COMBUSTION ENGINEERING OWNERS GROUP

CENPD-279
SUPPLEMENT 6

ANNUAL REPORT ON
ABB CE ECCS PERFORMANCE
EVALUATION MODELS

February 1995

PARCH Model of Young's Modulus for Zircaloy

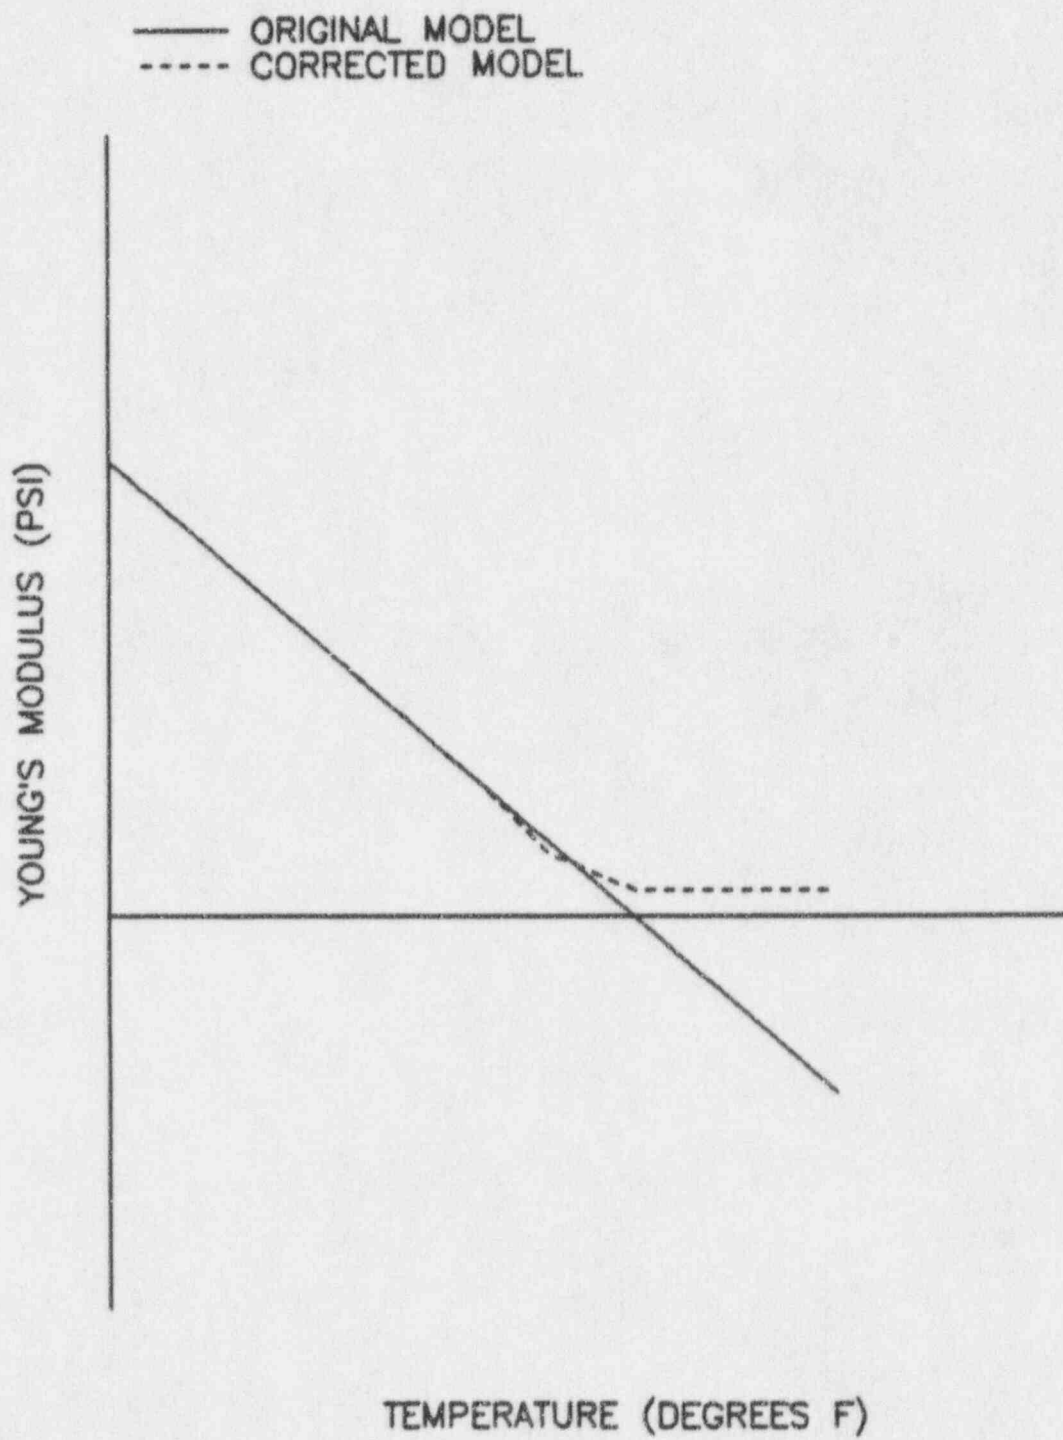
where T_c is the cladding temperature in °F. This is correct for temperatures up to about 1760°F. At higher cladding temperatures, this expression predicts too small a value for Young's modulus. As temperature increases, it falls to zero and becomes negative. The resulting temperature dependence of Young's modulus is shown by the solid line in Figure 1. This is incorrect for higher temperatures.

Two conditions must be satisfied for the error in Young's modulus to affect cladding temperature. First, cladding temperature must exceed about 1760°F where the error in Young's modulus becomes significant, Figure 1. Second, the cladding must not rupture until temperatures above this threshold are exceeded.

The error is corrected by revising the correlation for Young's modulus of zirconium in PARCH to follow the representation used in STRIKIN-II, Reference 10. The STRIKIN-II model uses the same linear fit for Young's modulus as PARCH does until it deviates from a straight line fit. Linear interpolation from a table is used above this temperature with a minimum value of Young's modulus at higher temperatures. The corrected representation Young's modulus is shown by the broken line in Figure 1.
